Project: 15078- Santa Rosa Charter School for the Arts

PCO: 045

Proposed Change Order

Subject: Low Voltage & Security Revisions

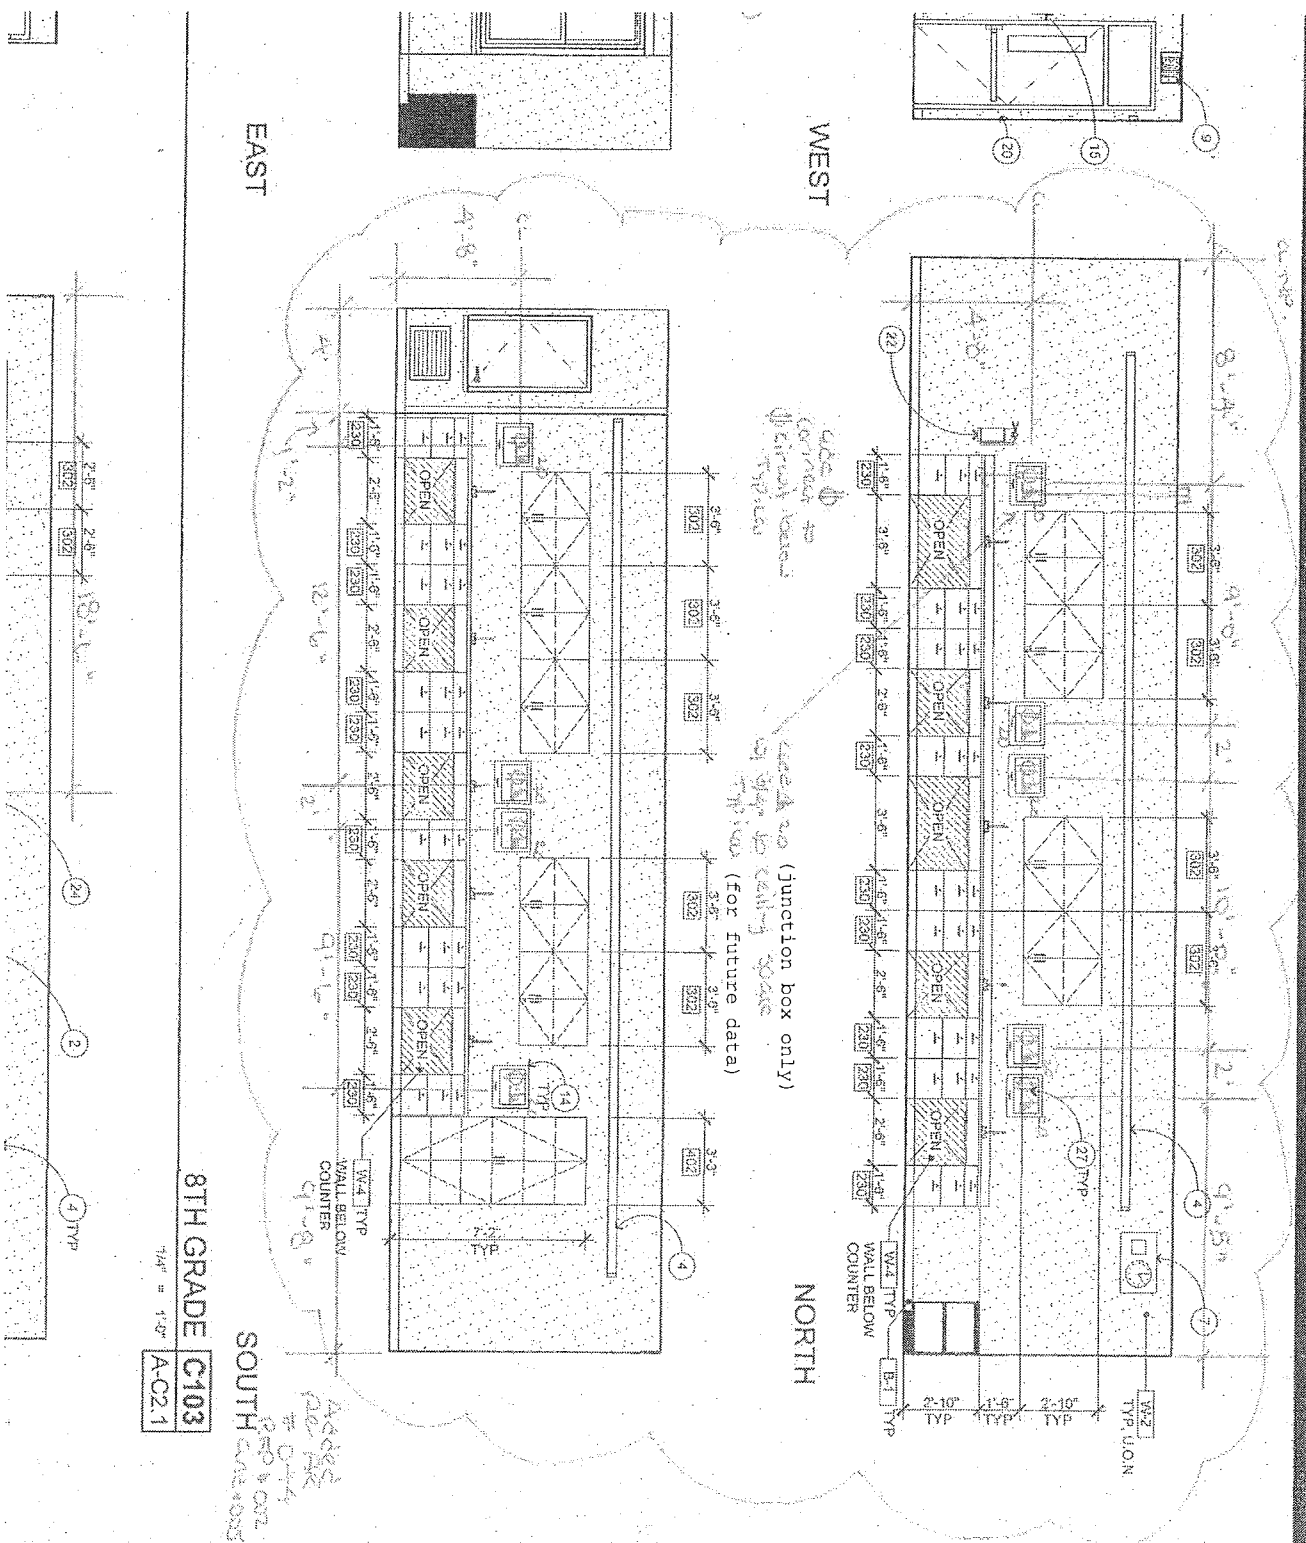
1. Provide and install (9) additional duplex receptacles (per attached sketch) behind the monitors located on the north and south walls of Classroom C103. (work completed)

2. Provide and install (9) junction boxes and conduit stubs to ceiling space for future data behind monitors located on the north and south walls of Classroom C103. (work completed)

6. Add AV, data and power to accommodate flat panel displays at Buildings A, B, C and Portables. See attached elevation drawings and floor plans showing all added devices, boxes and conduit. (Rough in completed other than in the portables)

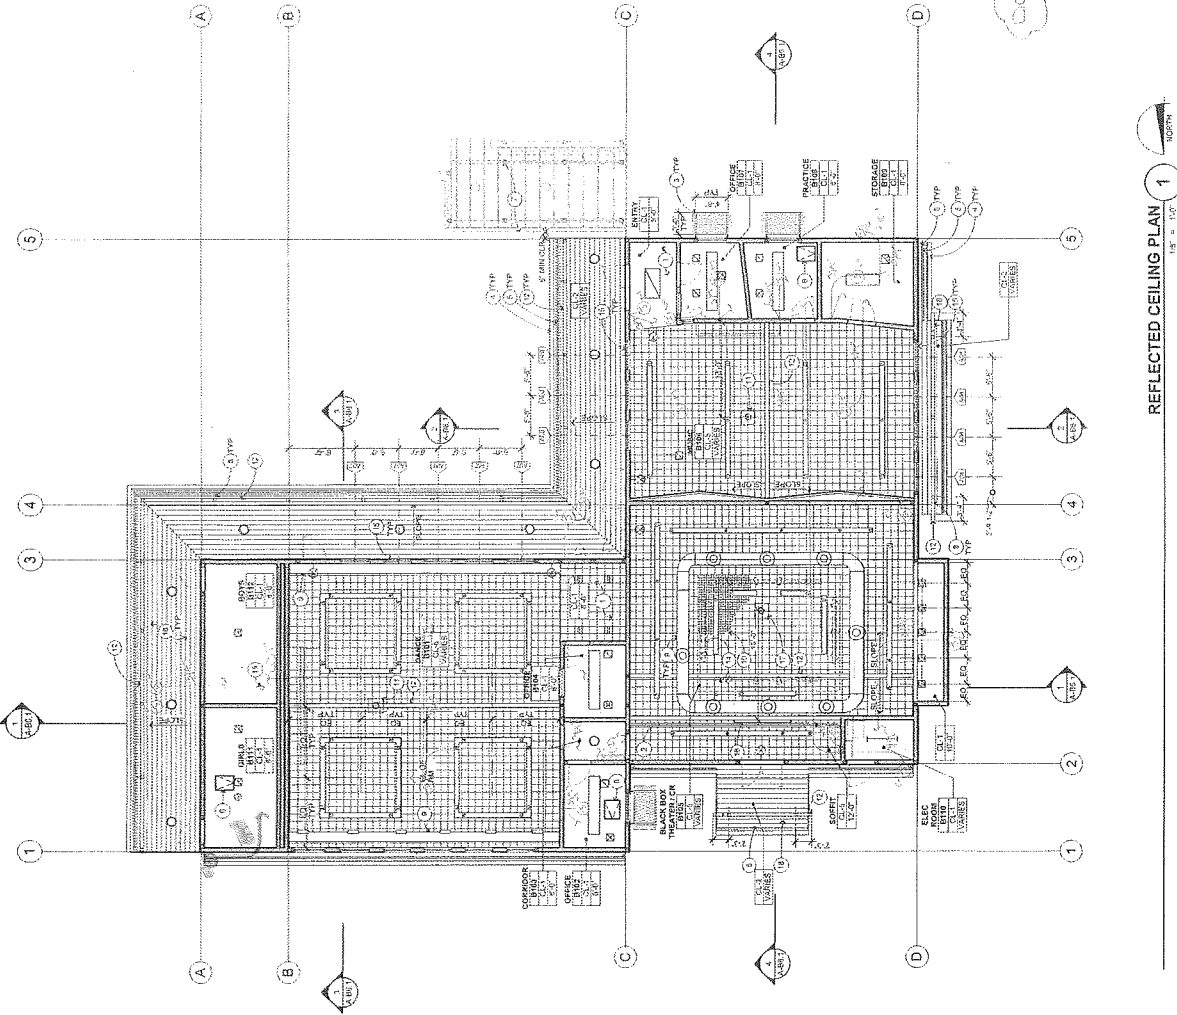
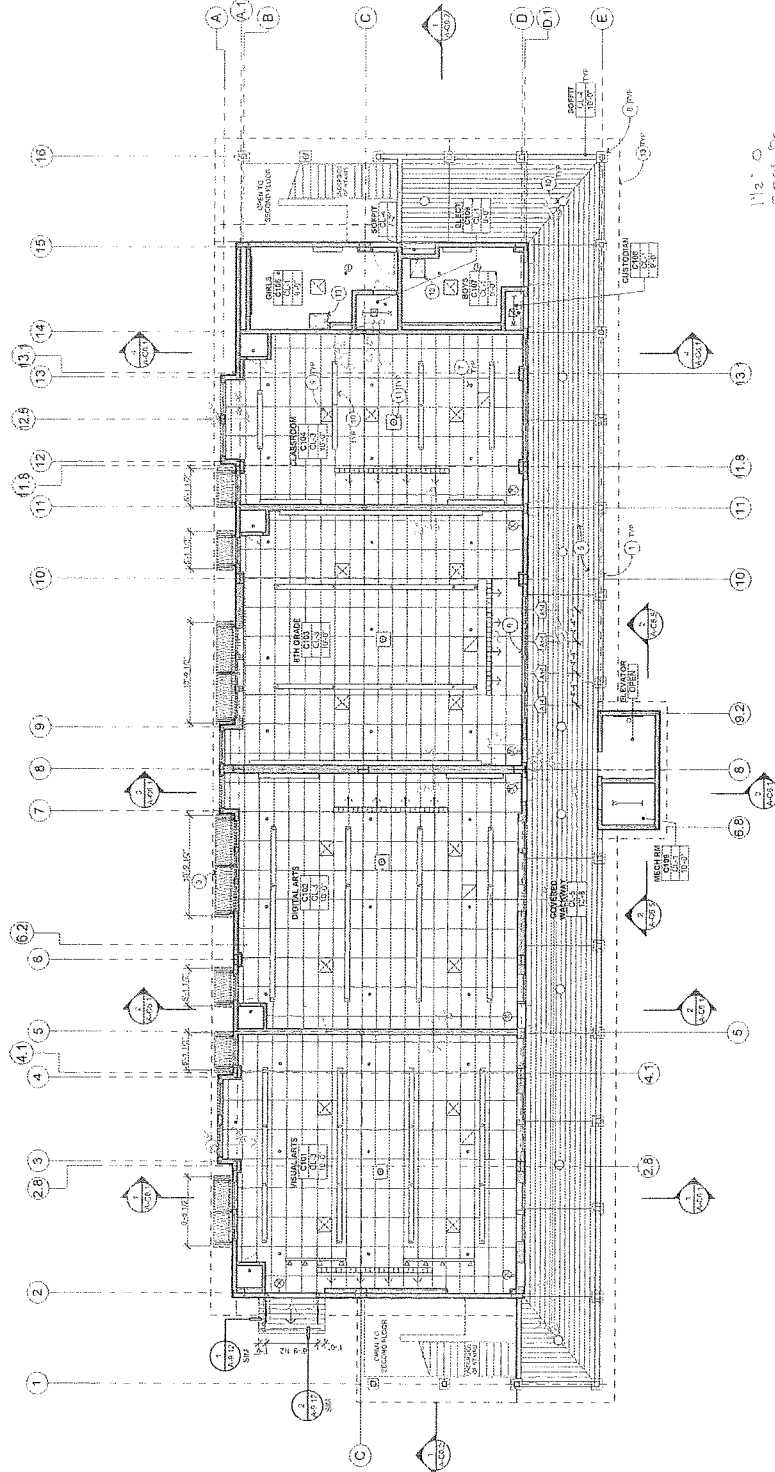
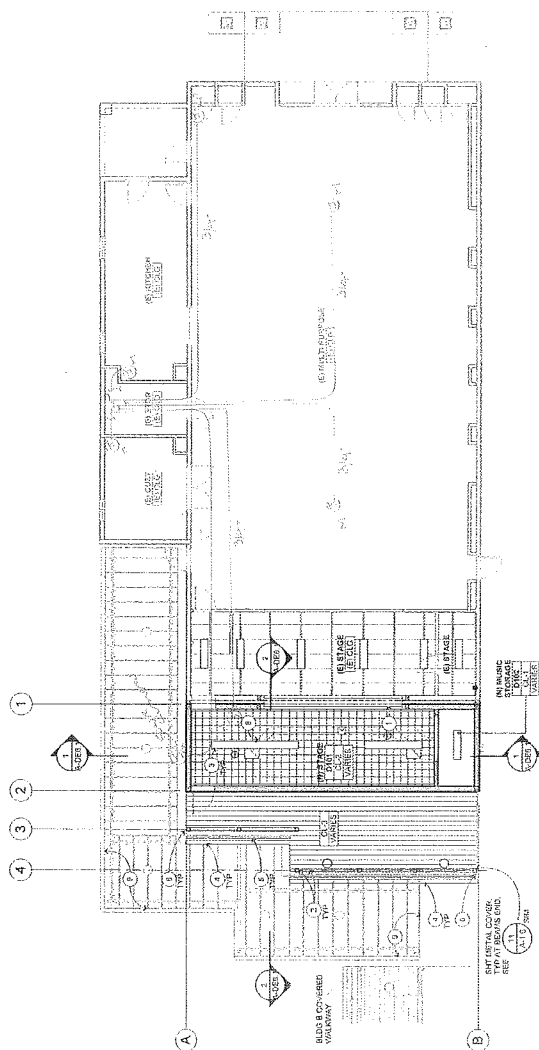
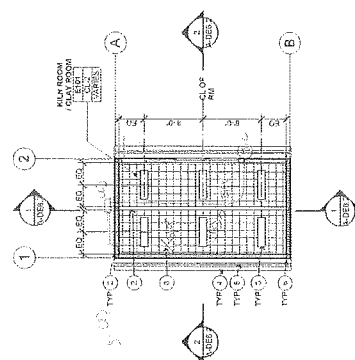
1. Provide and install conduit and back boxes for future security system per attached design.
2. Create infrastructure drawings with conduit and back boxes identified. Northern completed (attached) and ACME including in their design drawings.
3. Provide System Design and Planning for Security Cameras, Security Alarm and Access Control – ACME currently working on – to be completed in 2 to 3 weeks.
4. Provide CAD Shop Drawings with initial layout and design (Digital versions only) – ACME currently working on – to be completed in 2 to 3 weeks.
5. Provide site survey and determine best layout for conduit and back box locations for future security devices - Done

1. To confirm, ACME quote is only the design and CAD work.
2. We have completed the installation of all conduit and back boxes in Buildings A, B, and C.
3. Please note that we have included cost for roughing in for keypads at the Portables (not shown on the sketches) and a keypad in the 8th Grade Classroom Building C (not shown on the sketches)
